# Technical Service Bulletin

SUBJECT  <b>REPLACEMENT OF AIR INTAKE HOSE CLAMPS (F/FIX)</b>	GROUP  <b>ENGINE MECHANICAL</b>
	NO.  <b>08-20-004</b>
	DATE  <b>FEBRUARY 4, 2008</b>
	MODEL  <b>TUCSON</b>

**This bulletin replaces 05-20-010-1 to include revisions to the WARRANTY INFORMATION.**

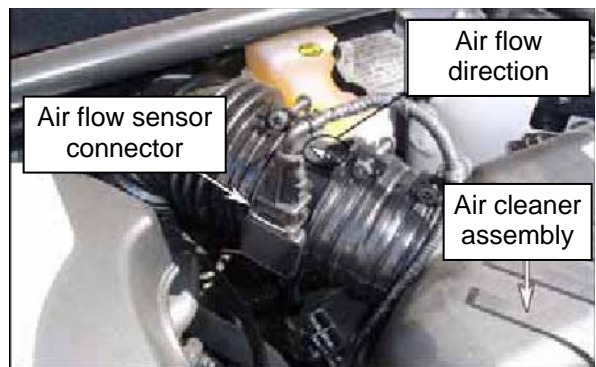
Some Tucson (JM) vehicles with 2.7L engines may experience rough idle and illumination of the check engine light. This may be caused by loose air intake hose clamps around the Mass Air Flow Sensor.

A new type clamp is available that provides a more secure attachment.

PART NAME	PART NUMBER		REMARKS
	OLD	NEW	
Hose Clamp			2 required
	14711-90006B	28192-2E500	
	Wire type clamp	Band type clamp

1. Ensure that the vehicle is within the affected vehicle production date range, and has the wire type clamp around the Mass Air Flow Sensor.
2. Turn the ignition to the off position.
3. Disconnect the Mass Air Flow Sensor.
4. Loosen the two wire type hose clamps and remove the Mass Air Flow Sensor.

5. Remove the old wire type hose clamps.

6. Install the new band type hose clamps on the two intake hoses.

7. Reinstall the Mass Air Flow Sensor and tighten the new hose clamps.

Tightening Torque:  
0.4-0.5 (2.9-3.6) kgf.m (lb.ft)
